SERVICE BULLETIN

No. 97
November 1, 1998

TREAD MARKINGS PASSENGER AND LIGHT TRUCK TIRES

An illustration of the Radial Passenger markings is noted below:

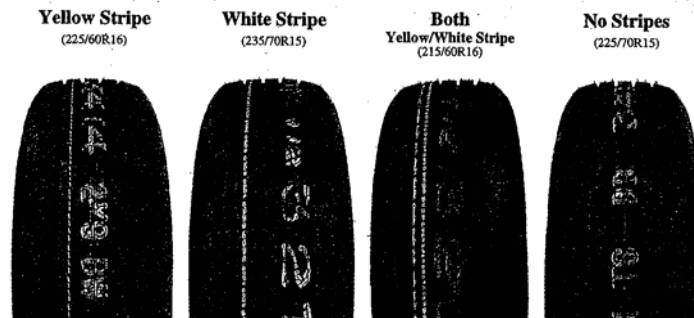
All tires with an EVEN rim diameter (12", 14", 16", etc.) and an EVEN number in the second digit of the cross-section (185, 225, 245, etc.) will be identified with a circumferential **yellow** stripe on the tread.

All tires with an ODD number in the second digit of the cross-section (195, 215, 235, etc.) will be identified with a circumferential **white** stripe on the tread.

All tires with an EVEN rim diameter (12", 14", 16", etc.) and an ODD number in the second digit of the cross-section (195, 215, 235, etc.) will be identified with **both** a yellow and a white circumferential stripe on the tread.

All tires with an ODD rim diameter (13", 15", 17", etc.) and an EVEN number in the second digit of the cross-section (185, 225, 245, etc.) will not exhibit circumferential identification stripes on the tread.

An illustration of the Radial Light Truck markings is noted below:

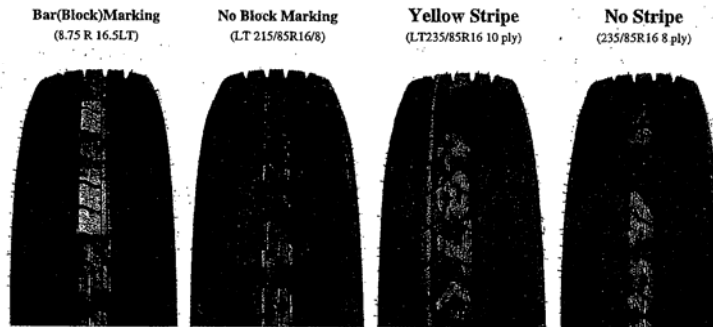
All 16.5" radial light truck tires will be identified with a 1.75" bar mark (block) every few inches around tire on the tread.

All sizes OTHER than 16.5" radial light truck tires will **not** be identified with the 1.75" bar mark (block) on the tread.

On multiple load ranges in the same size only, the Load Range E (10-ply rated) tires will exhibit a .25" wide circumferential **yellow** identification stripe on the tread.

On multiple load ranges in the same size only, any tires with Load Ranges OTHER than Load Range E (10-ply rated) will not exhibit any circumferential identification stripe.
